TECHNICAL STAFF REPORT

Case No./Petitioner: PB 420 – Montevideo Crossing Royal Farms
Mark Levy, MIT-Montevideo, LLC

Request: For the Planning Board to approve the Optional Design Project (ODP) in a Commercial Redevelopment (CR) Overlay District for Royal Farms at Montevideo Crossing in accordance with Section 121.1.H of the Zoning Regulations.

2 LEFT ELEVATION
SCALE = 1/4" = 1'-0"

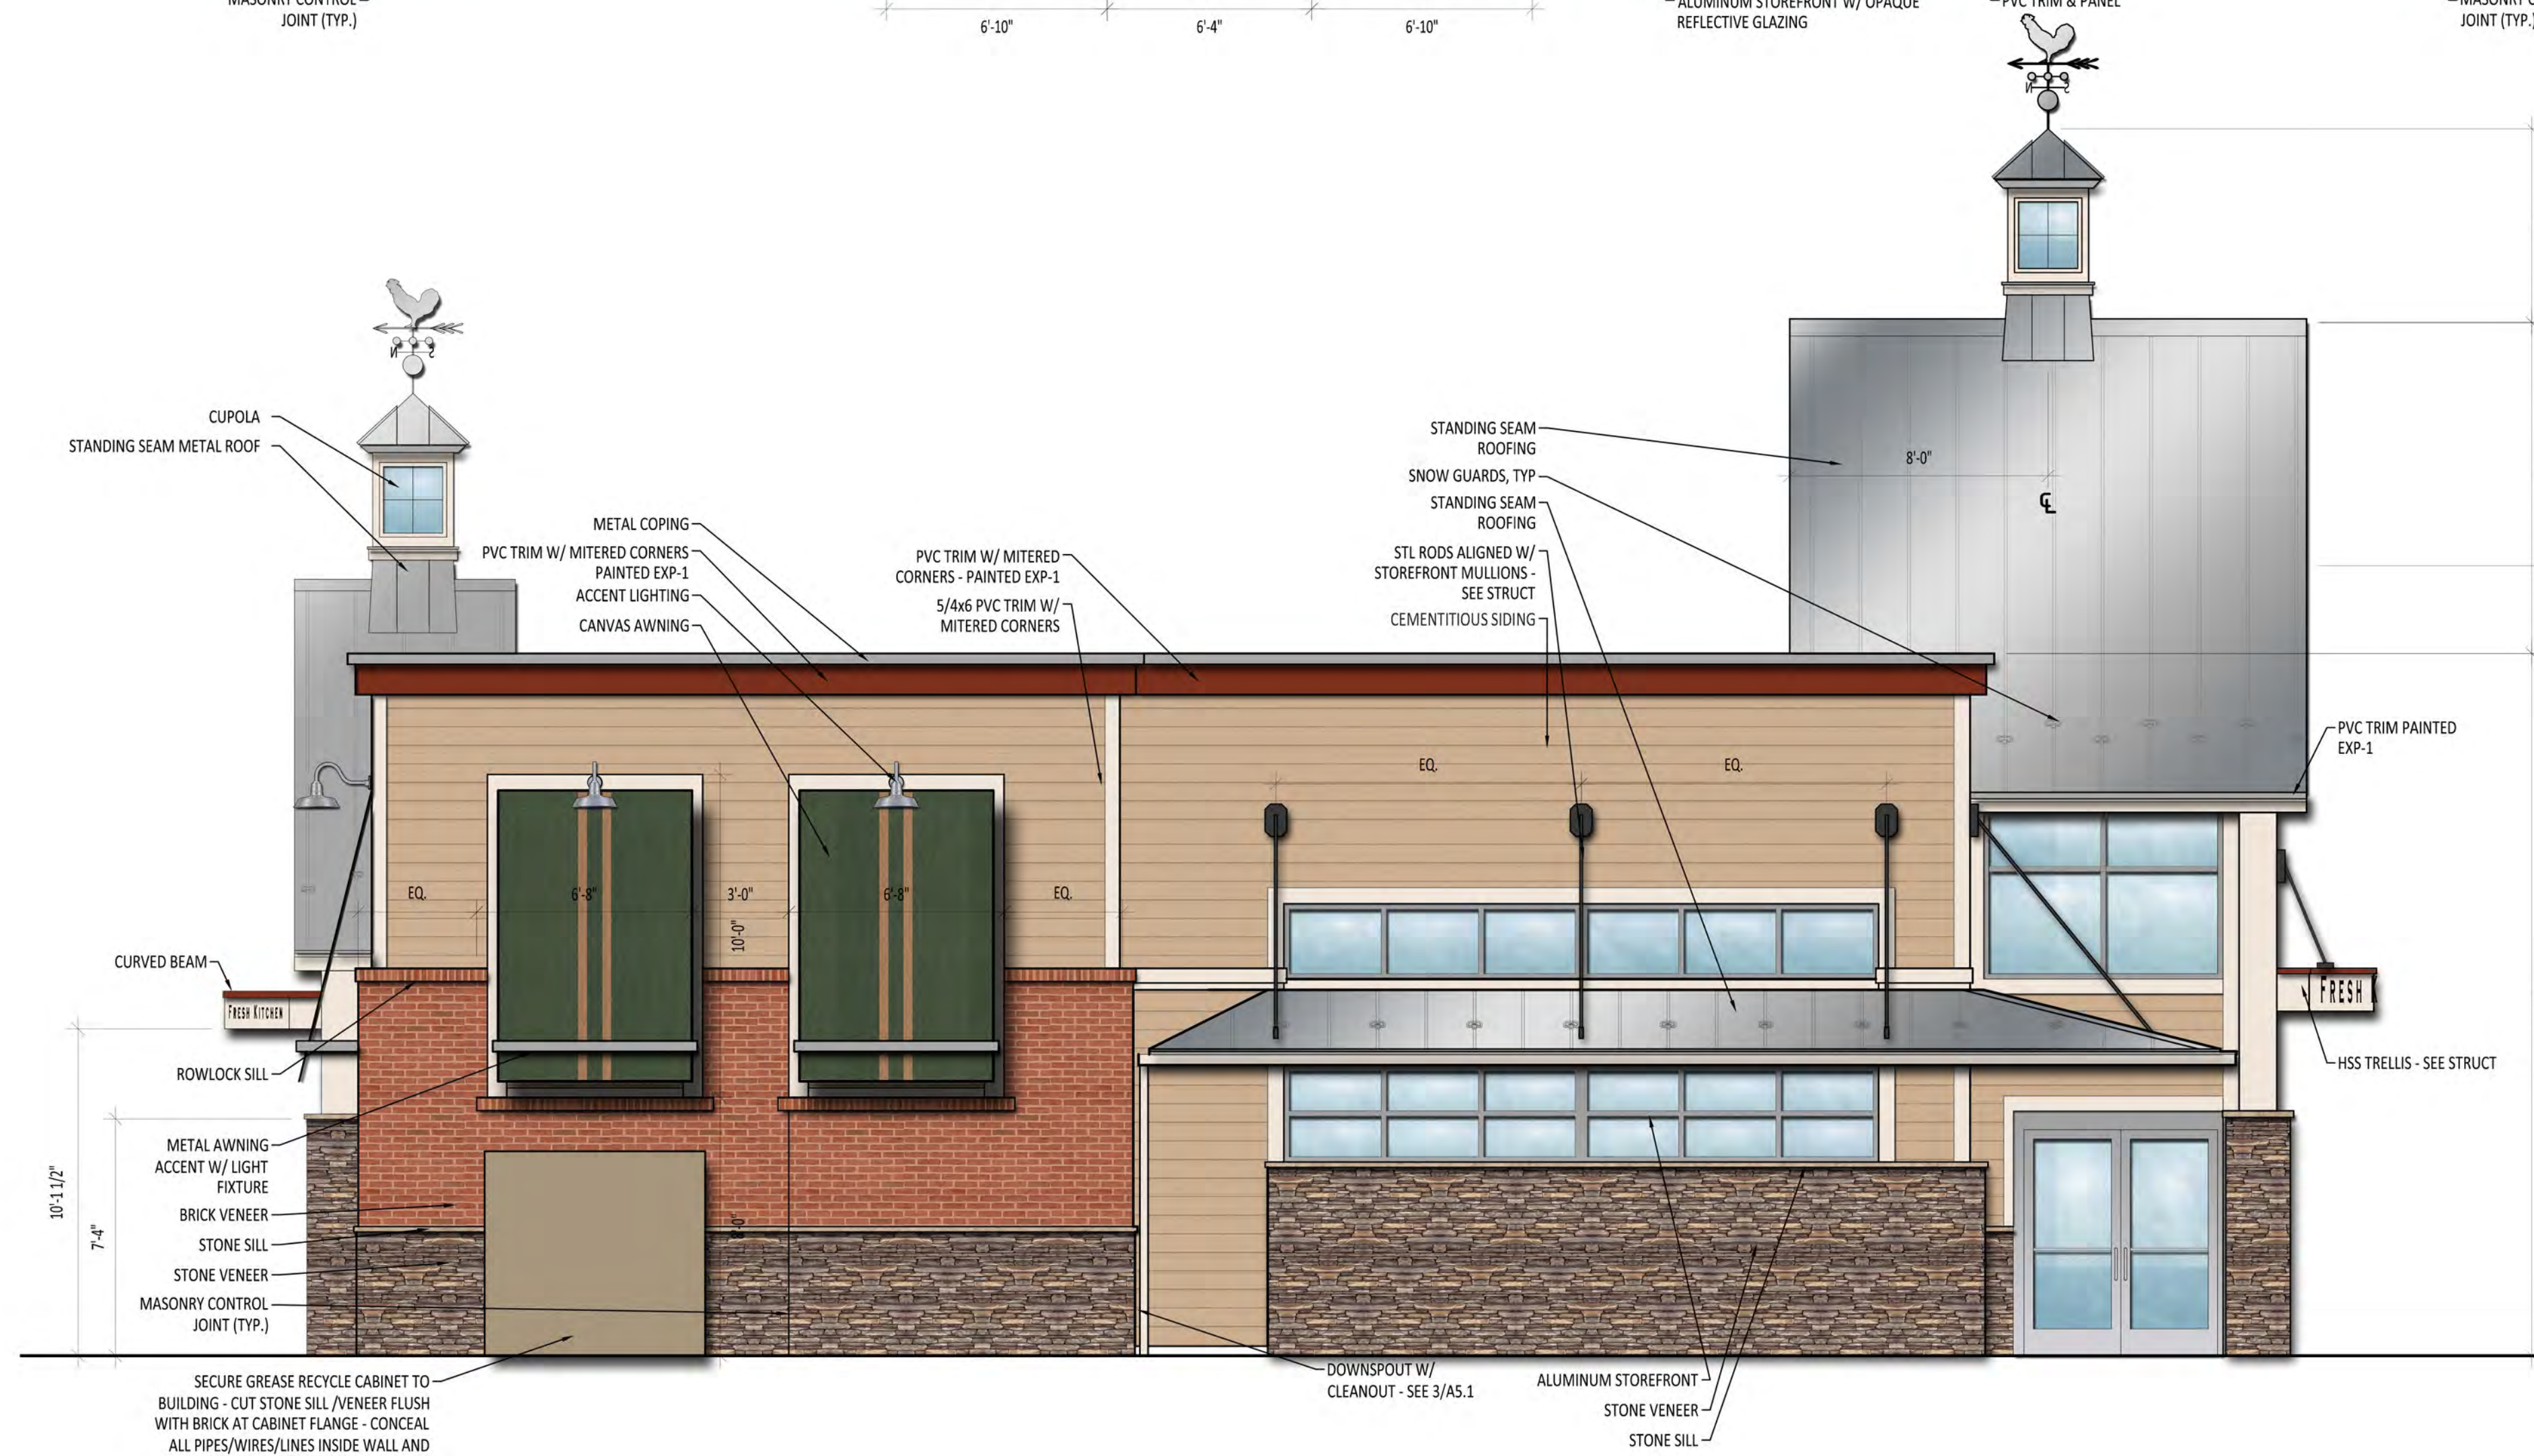
Royal Farms altered their standard architecture to better match that of the CVS, thereby visually connecting the two buildings and creating a unified theme. Brick color will match, siding will match the top band of CVS' exterior insulation and finishing system (EIFS), and white trim board will correspond with CVS' peach colored EIFS. See Appendix C.
